## STAFF REPORT

## APPLICATION: AGENDA ITEM I.3 SEPTEMBER 26, 2024 MEETING

Re: **IWWA Application: 1597 New London Turnpike  
Subdivision and Single Family House**

Re: 1597 New London Turnpike 2-Lot Subdivision

### **Site Description**

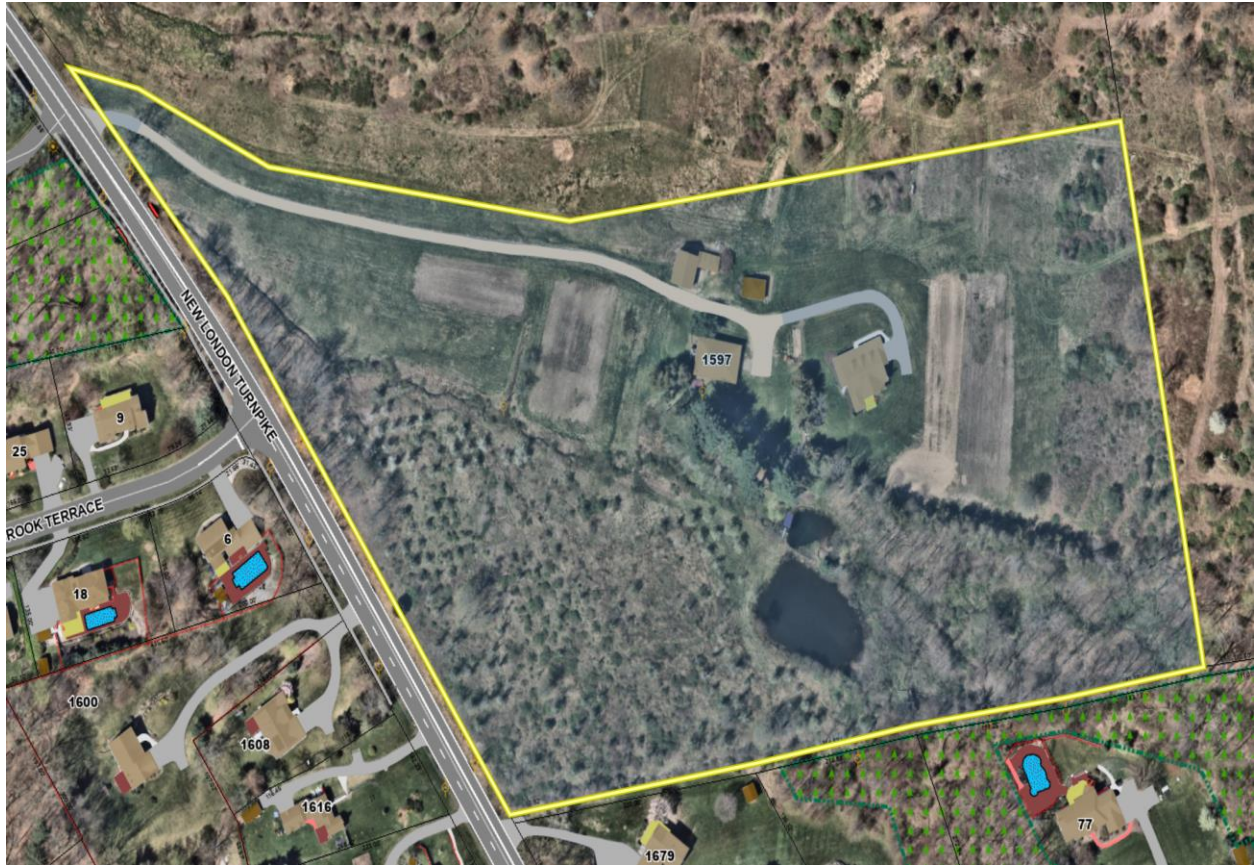
The property is approximately 13.8 acres, the proposed single lot is approximately 2.08 acres within the Rural Residence Zone. The property contains a pond (Bonas Pond) and is near the headwaters of Wickham Brook, which flows east to west across the property. The proposed subdivided lot contains wetland soils, depicted on the site plan as ranging from wetland flag #25-#31. The regulated activities proposed within the 100' upland review area include clearing, grading and water quality structures (basin and trench) as shown on Sheet #4.
